Board of Mayor and Aldermen
July 2, 2024 Regular Meeting @ 7:00 PM

Item #: 8.C. Approve Change Order #3 with Baron Construction, LLC for the Public Works and Community Development Services Facility.

This is a change order for the construction of the Public Works and Community Development Services Facility.

E302

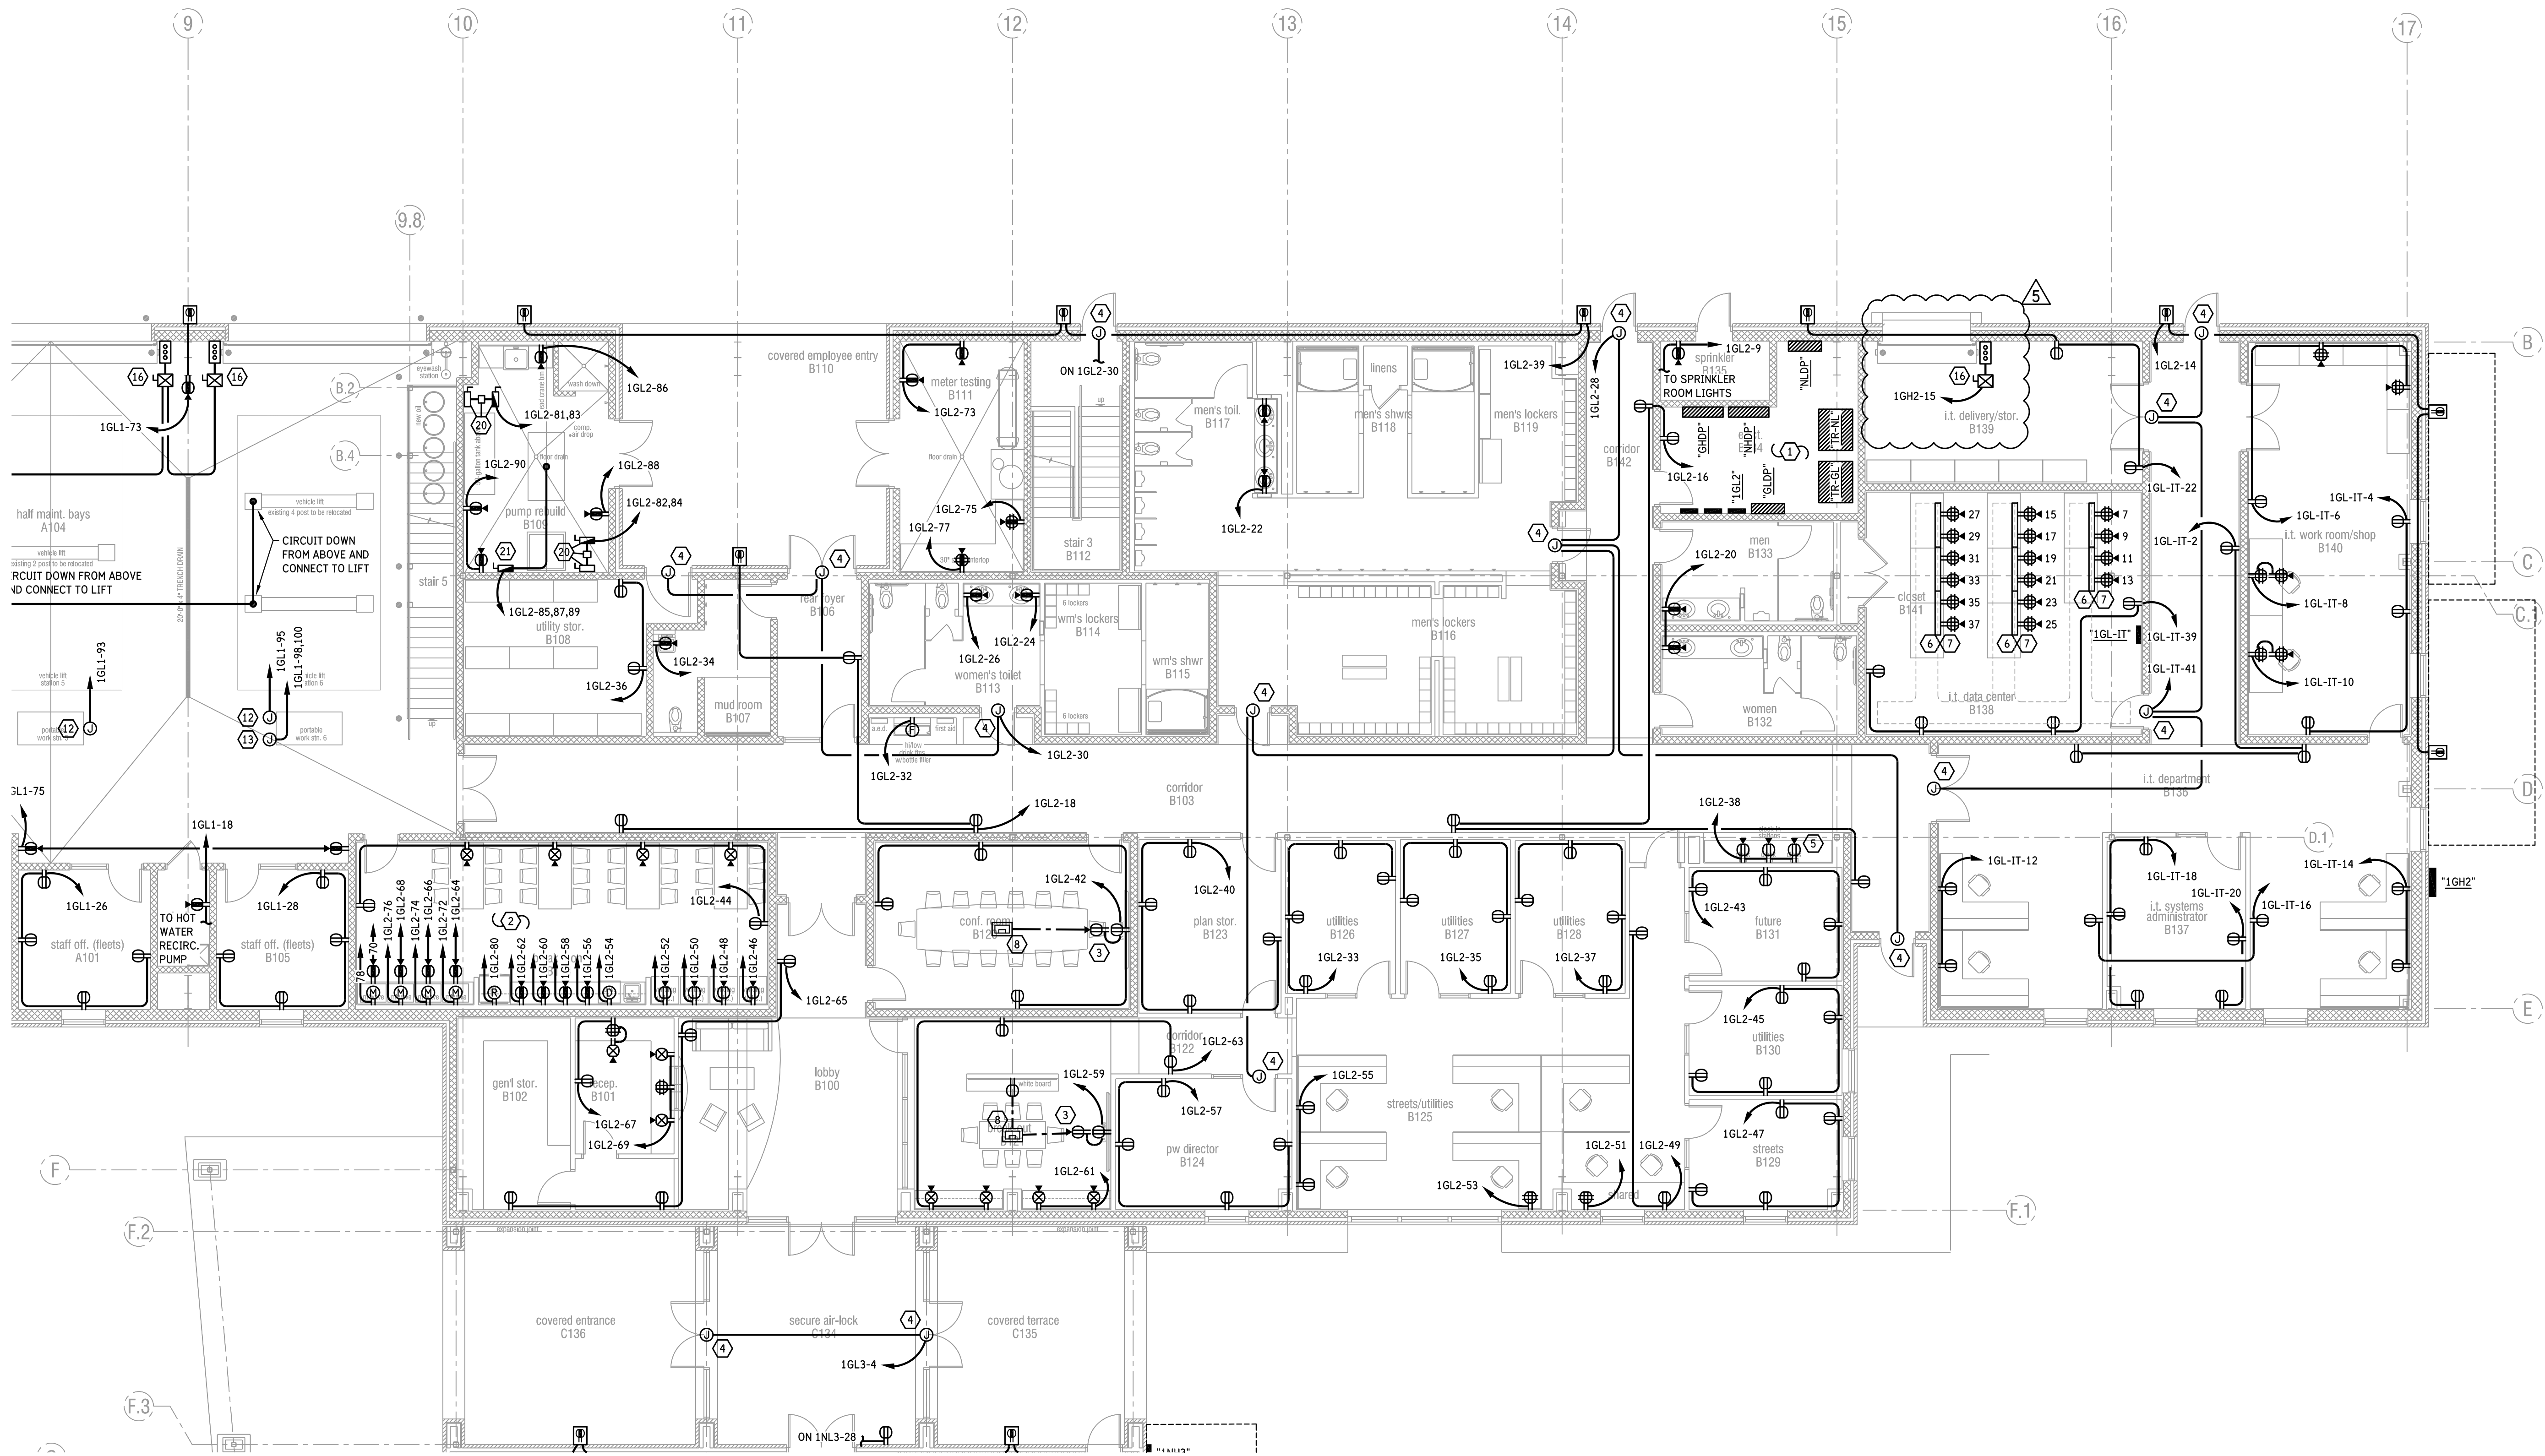
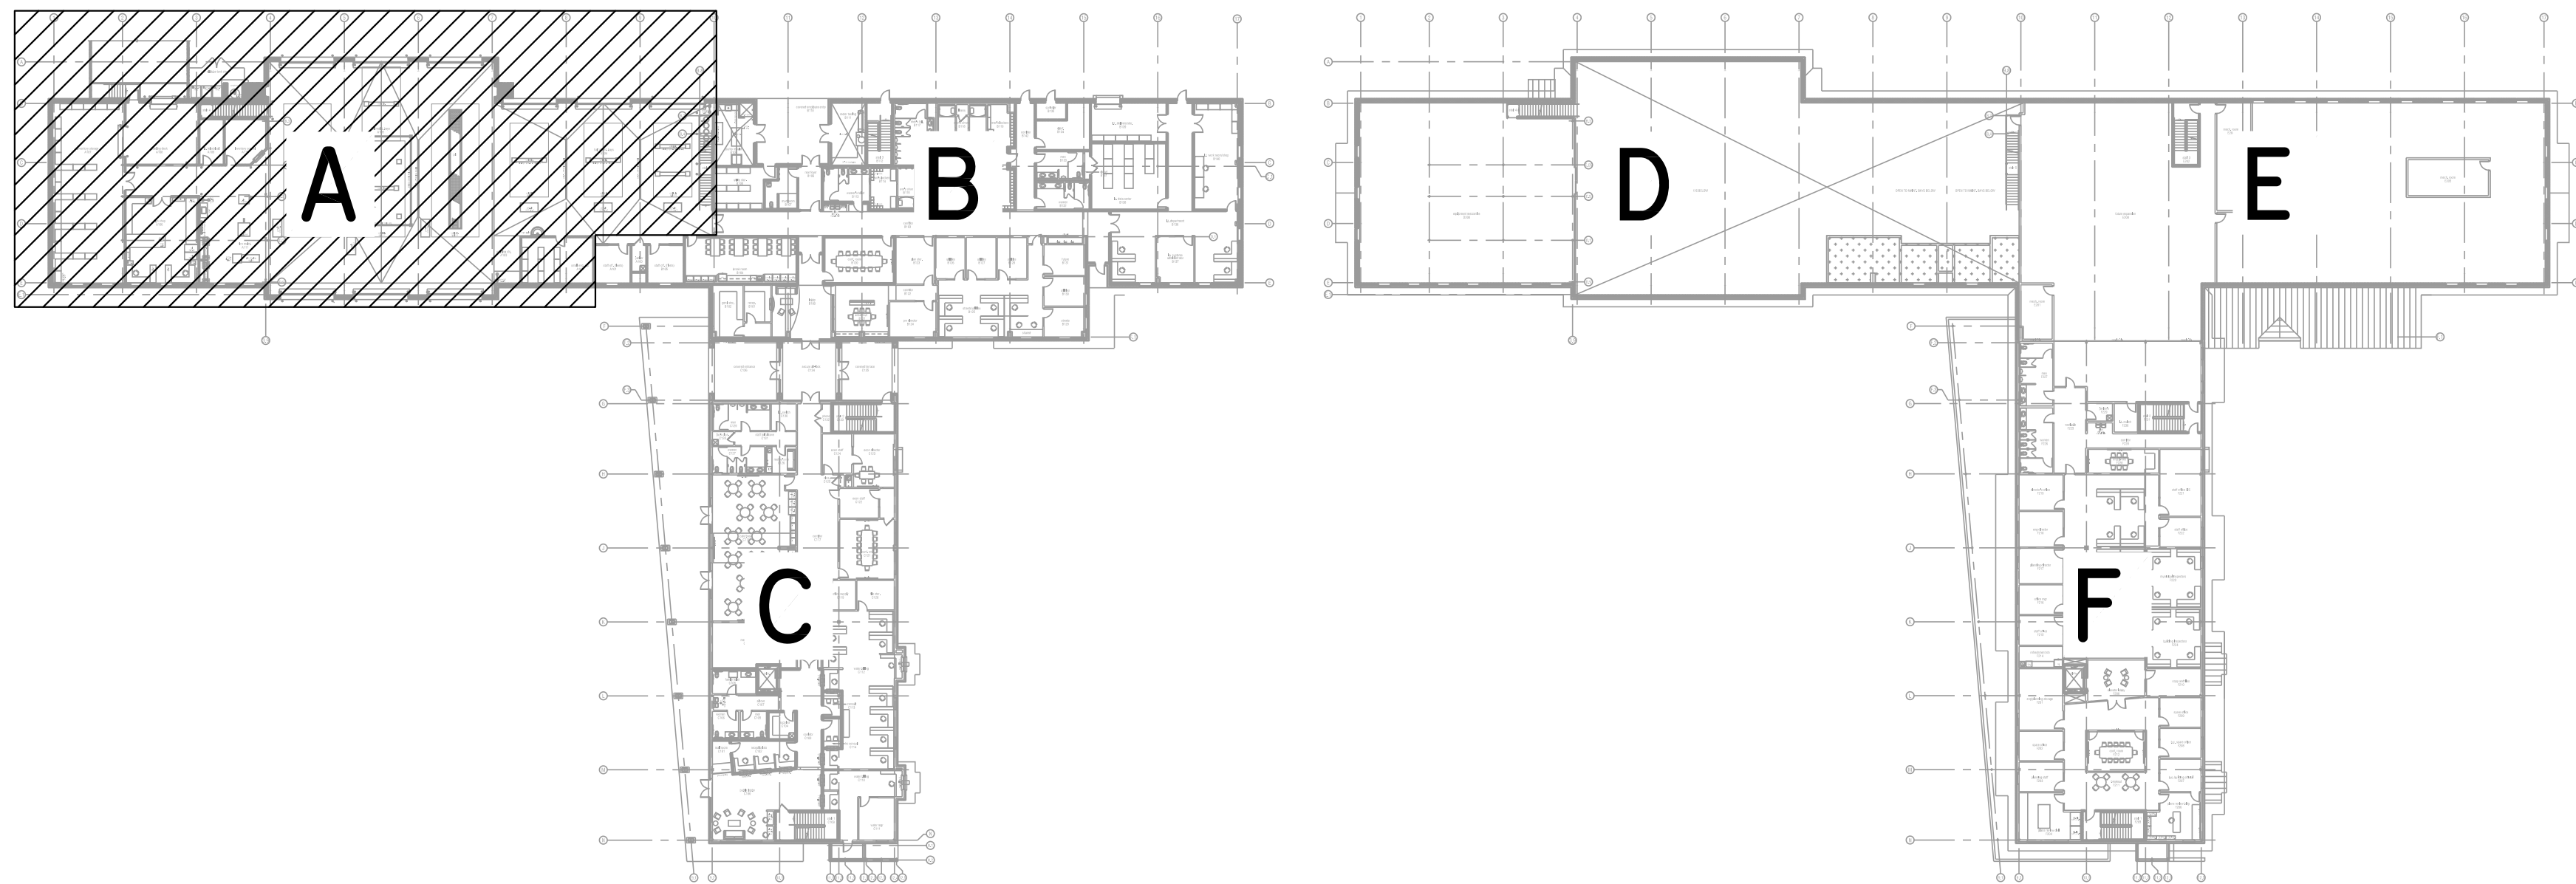
Question	Question from Roy Bruce Baron Construction, LLC on Thursday, Mar 21, 2024 at 02:18 PM CDT Tyler, The electrical drawings do not show power/circuits for the overhead doors at Exterior Vehicle Bldg 1 (sheet E308). Can you please send over a drawing showing the design intent for this? Also, per previous email correspondence can we please get a revised drawing(s) for Area A showing the circuits for the two overhead doors at Loading Dock A108 area (sheet E302). Attachments RE_ La Vergne PW - Dock Levelers _ Electrical Clarification.pdf
Official Response	Response from Tyler Ball Harpeth Park Engineering PLLC on Wednesday, Apr 3, 2024 at 09:27 AM CDT See attached revised drawings concerning the overhead doors. Narrative of changes: E302 Added overhead door connection for Inventory Storage A107. Revised overhead door connection in Loading Dock A108 for clarification. Edited Keyed Note 16 for clarification. E303 Revised overhead door connection in I.T. Delivery/Storage B139 for clarification. E308 Added overhead door connections for the Exterior Vehicle and Equipment 1 X100 shed. E702 Revised panel schedules per overhead door connections. Attachments E302 (ESD #5).pdf, E702 (ESD #5).pdf, E303 (ESD #5).pdf, E308 (ESD #5).pdf

E302 Added overhead door connection for Inventory Storage A107. Revised overhead door connection in Loading Dock A108 for clarification. Edited Keyed Note 16 for clarification.
